APPROVED MINUTES OF THE MEETING

January 21, 2010

Project: Alaskan Way Viaduct Seawall Replacement

Phase: Design Update

Figure 1: North Portal Options 1 and 2

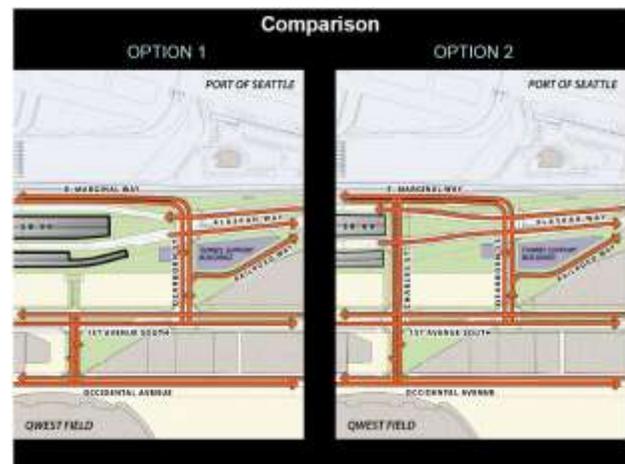
In the north portal area, how will pedestrians go north across Aurora?

Pedestrian connections will be on both sides of 6th Ave to the north of the entry ramp only. Pedestrians looking to cross over Aurora will have to cross at one of the streets south of the tunnel entrance. The entrance and exits in the vicinity will not allow for pedestrian crossings due to the elevation changes. Aurora width is 92-feet wide and becomes wider. We have not finalized this design. We would like to maintain 14-foot sidewalk widths throughout.

On Harrison, when you stand at the tunnel, will that be a horrible place to stand?

There are some potentially interesting views, though noisy. There would be an opportunity to create viewpoints. This access point is similar to entering a hill as opposed to dropping down.

Figure 4: South Portal Area Overview Sketch

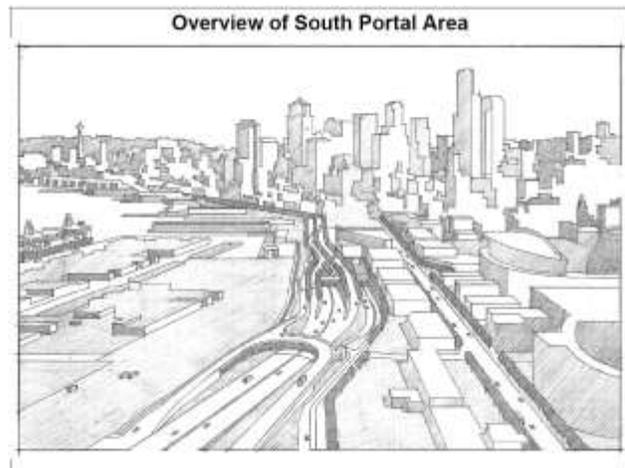
The reason for having a sidewalk that goes along the overpass, is this to allow pedestrian traffic when the tail track is occupied?

Yes, this is to provide access for the when tail track access is blocked. In many ways pedestrian access might become more desirable due to the views. Stairs are intended for the corner of the overpass near S. Royal Brougham Way. How to turn this functional element into something that becomes more of a gateway is something for which we'll be seeking input.

Is the U-overpass always open? Are you looking at this overpass as an integral part of the portal expression?

The nature of the edge of the overpass will need to be addressed. I think the way the stair is created, the columns and how they're organized, will all be important aspects. We have three principle elements this corridor, the ramps and entrance, the overpass, and this element. The team has not gotten that far to speak to it.

There seems to be a plaza opportunity near the south portal between Dearborn St. and Charles St.

We believe there may be utility issues. Transmission lines run through this area and limit our options. We don't know the programming yet for some of these sites. We will be looking at this. This design is evolving. We are also looking to possibly move Dearborn St. slightly to the south which would change our options at this site.

I had a reaction to intersection of 1st and Dearborn and question whether the corner could be expanded to create a clearer path along Railroad Way S.

We can look at the view corridor along the Railroad Way. It is all a part of the ongoing discussion. Meaningful open space is critical.

On the Little H, (overpass) concerning the stairway, I think this is important to keep.
